Re: Parking Calculation;
93 State Street, Newburyport, MA (the "Property")
Assessor's Map: 14 Lot: 40 and 39

Reference is made to the above-captioned matter. In that connection, I have attached revised site plans showing the addition of one () parking space. The Applicant provides this change, notwithstanding;

93 STATE STREET
SITE LAYOUT, GRADING & EROSION CONTROL PLAN
 LOCATED IN
NEWBURYPORT, MASSACHUSETTS
 (ESSEX COUNTY)
 PREPARED FOR
INSTITUTION FOR SAVINGS

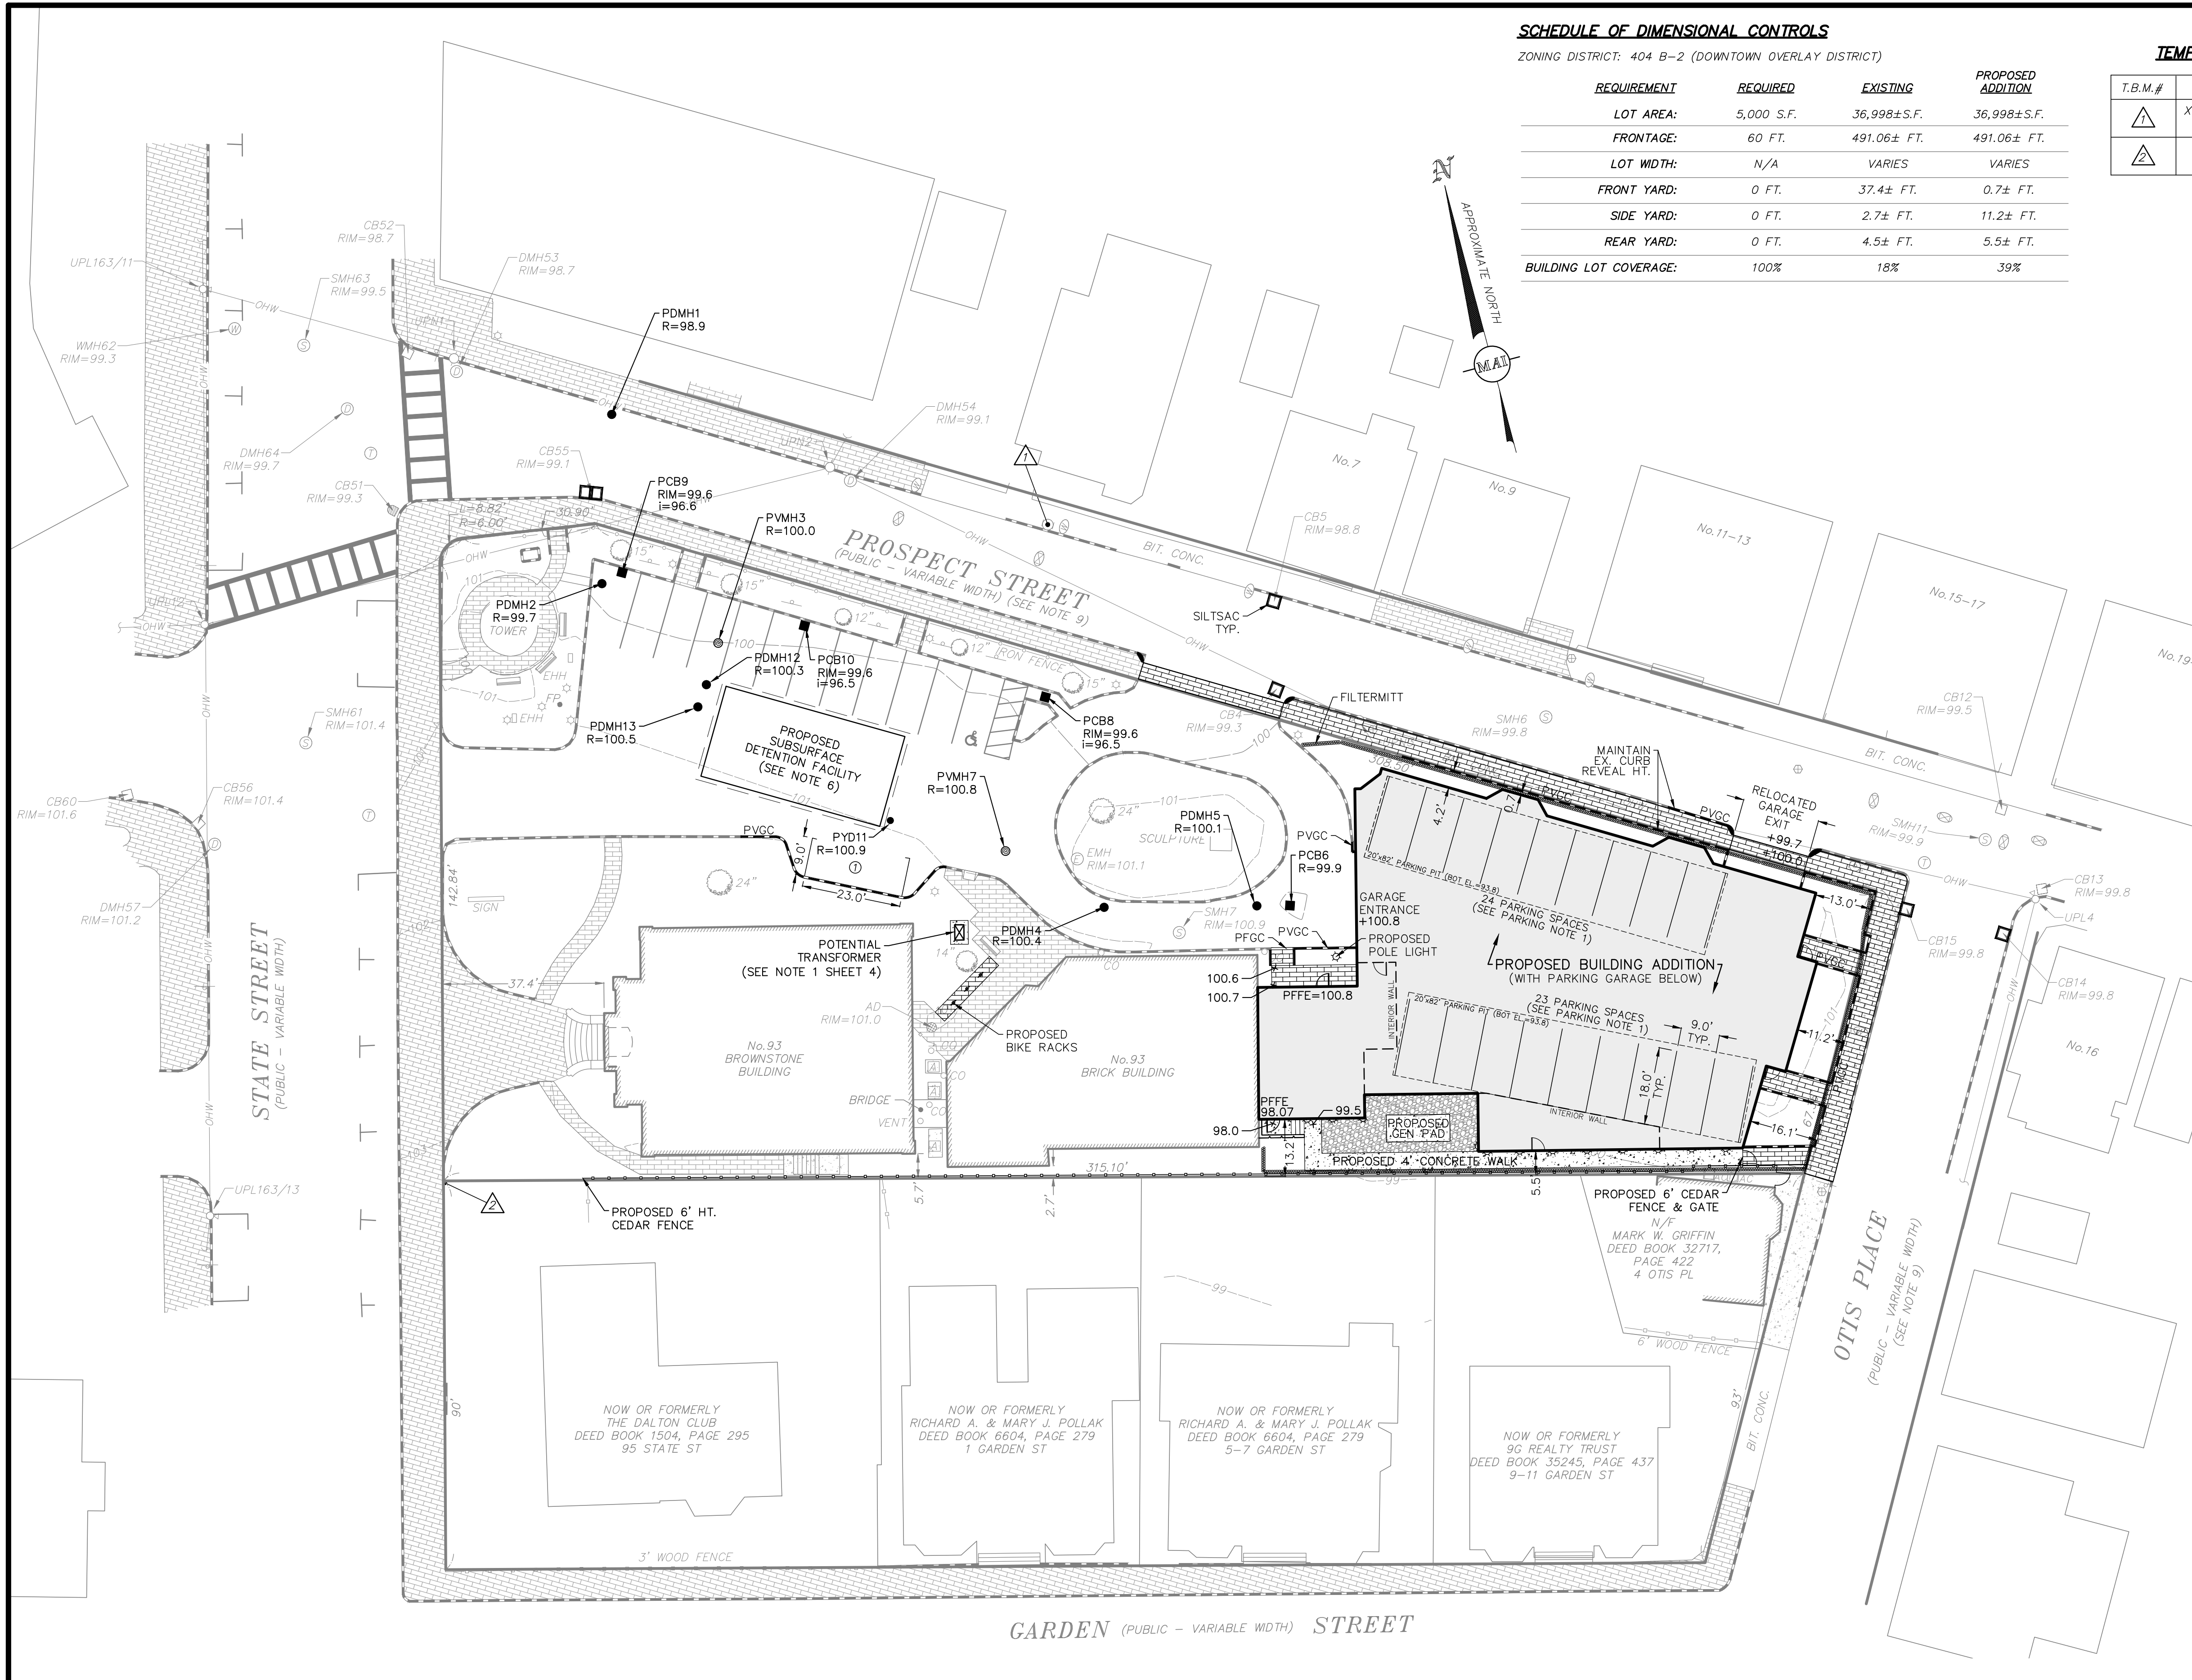
Please note, the Applicant has also added a bike rack to the plan near the door of the entry at the ATM.

REVISIONS	DATE	DESCRIPTION
06/24/20		ADD PARKING SPACE & BIKE RACKS
05/20/20		REVISED SUBMISSION
03/25/20		BUILDING/PARKING REDESIGN
02/06/20		PEER REVIEW COMMENTS 01/20/20

Specifically, there is existing 12,560 square footage of useable floor area, the Applicant is required to have 38 parking spaces; the existing condition on the Property is 36 parking spaces, two spaces short of the requirement.

The revised proposed addition includes 7,288 square feet which requires an additional 22 spaces.

In total between the existing structure (38 spaces required) and new addition (22 spaces required) under the brand new interpretation, the Bank is required to have 60 spaces and 60 will be provided. Ms. Blanchet, please confirm at your earliest convenience.

BICYCLE RACK
(NOT TO SCALE)

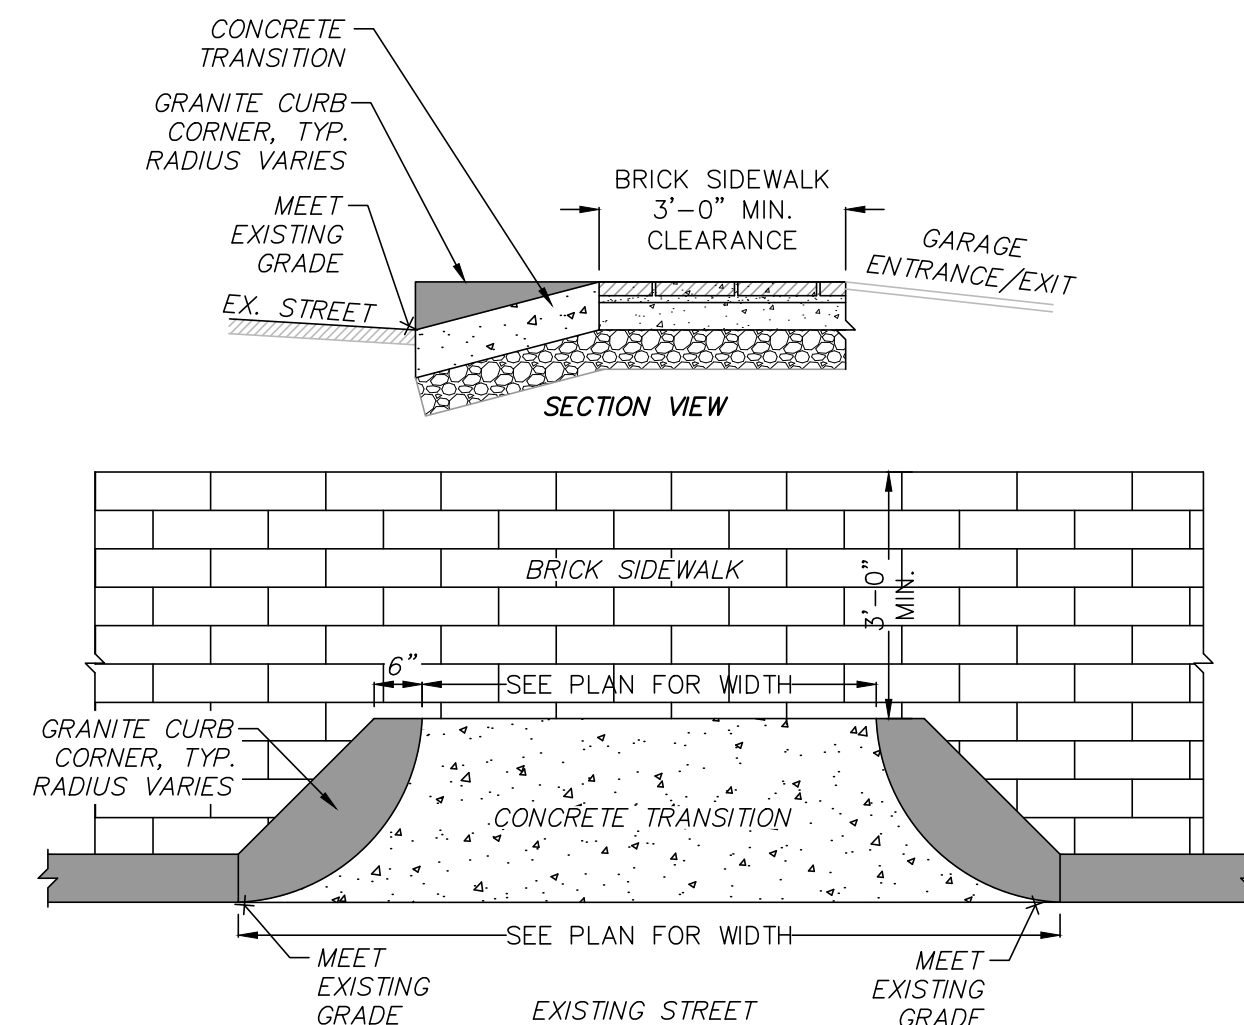
REVISIONS	DATE	DESCRIPTION
06/24/20	ADD BICYCLE RACK DETAIL	NE
05/20/20	REVISED SUBMISSION	NE
03/25/20	NO CHANGES THIS SHEET	NE
02/06/20	PEER REVIEW COMMENTS 01/20/20	NE

NOTE:
MAKE AND MODEL TO BE APPROVED BY PROJECT OWNER PRIOR TO INSTALLATION. REFER TO MANUFACTURER'S SPECIFICATIONS FOR DETAILS.
